Exelon Generation®

Peach Bottom Atomic Power Station, Units 2 and 3
Renewed Facility Operating License Nos. DPR-44 and DPR-56
NRC Docket Nos. 50-277 and 50-278

Subject: Extended Power Uprate License Amendment Request – Supplement 9
Response to Request for Additional Information

Response to Request for Additional Information – SRXB

Figure B-1 ZrO₂ Thickness as a Function of Maximum Temperature

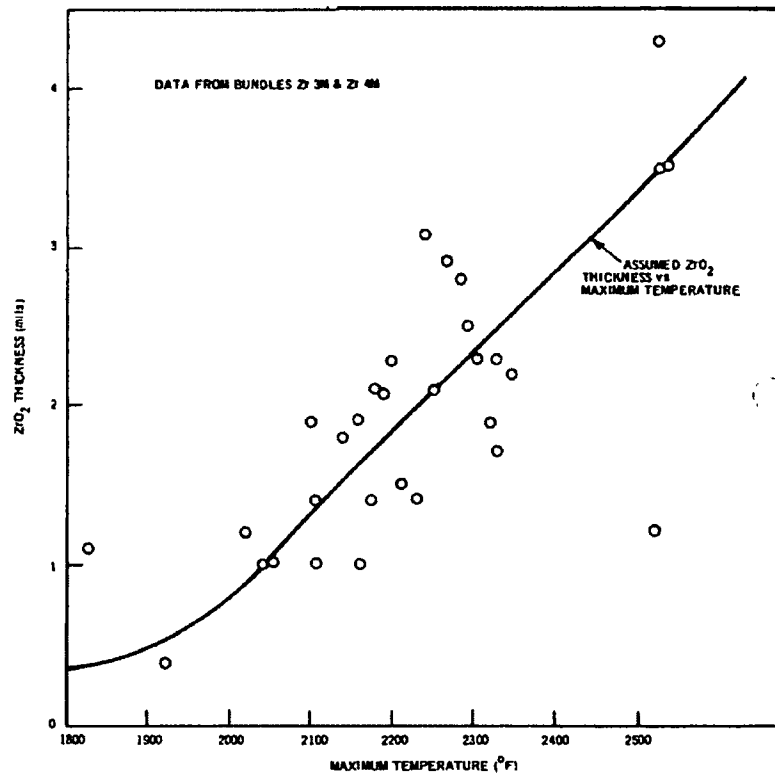
Please provide a reference to show where cladding oxidation has been demonstrated to be insignificant when the PCT is less than 1600 °F during ATWS events.

Section 3.4.3 of the Safety Evaluation for Reference 21-1 originally restricted upper bound PCT to 1600°F because: (a) the range of test data submitted as part of the code qualification extended only to 1600°F, and (b) the Monte Carlo Simulation presented in the SAFER Licensing Topical Report (LTR) was performed over a temperature range where effects such as metal-water reaction are negligible. Reference 21-2 was issued to remove the 1600°F limitation for the licensing basis PCT. The following is an excerpt describing the metal-water reaction as a function of temperature:

“The metal-water reaction does not become a factor until the cladding temperatures reach 1700°F and does not become significant until the cladding temperatures exceed 1800°F. When the upper bound PCT approaches 1800°F (where metal-water reaction is just beginning to become significant), the licensing basis PCT will be approaching 2200°F where it would be restricted by the 50.46 limit.”

The following figure from Reference 21-3 illustrates the Baker-Just zircaloy-water reaction equation used in the SAFER method which demonstrates that cladding oxidation is not significant below 1800°F.

Because the criteria to assure coolable core geometry (2200°F PCT and 17% local cladding oxidation thickness limit) for a loss of coolant accident are also applicable to an ATWS, the above references and discussion that demonstrate cladding oxidation is insignificant when PCT is less than 1600°F are also applicable to the ATWS analysis.

Figure RAI-22-1: Results Comparison for MSIVF and TTNBPF Events

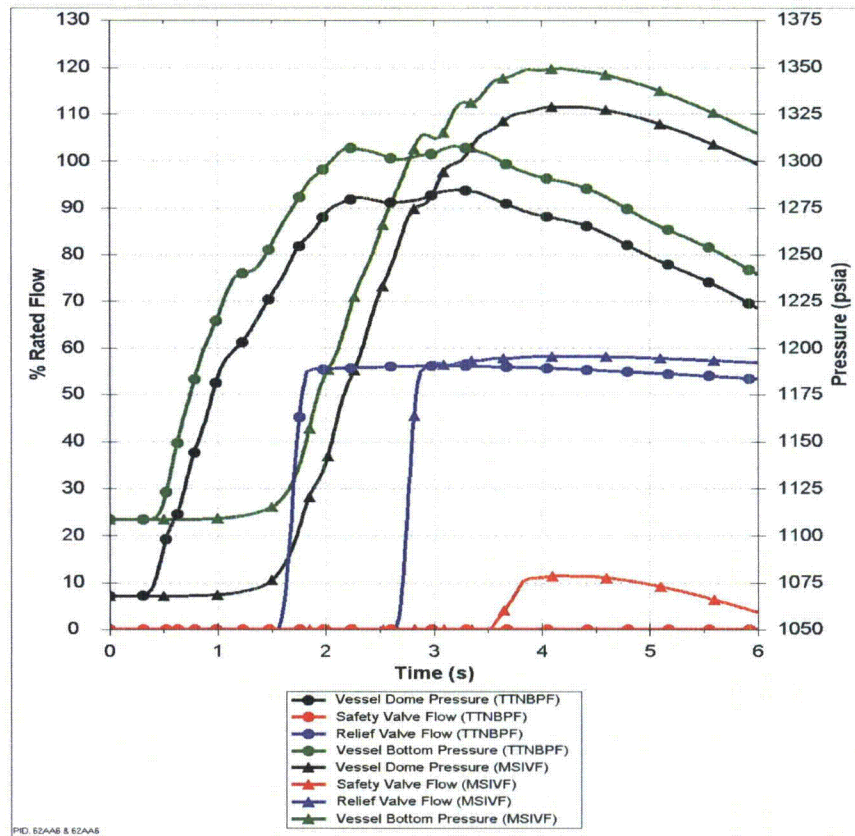
With respect to overpressure protection (i.e., Section 2.8.4.2 of the PUSAR), if an analysis was performed for the Turbine Trip with Bypass Failure and Scram on High Flux (TTNBPF) event, as it is required in Table E-1 of ELTR-1, please provide a plot comparing the pressure transients for the Main Steam Isolation Valve Closure with Scram on High Flux and the TTNBPF events. If a TTNBPF analysis was not performed for EPU, then justify why not.

An analysis was performed for the TTNBPF event, as required by Table E-1 of ELTR-1. The comparison plot of the MSIVF and TTNBPF events is provided in Figure RAI-22-1. The MSIVF event is clearly more limiting for both dome and reactor vessel bottom pressure.
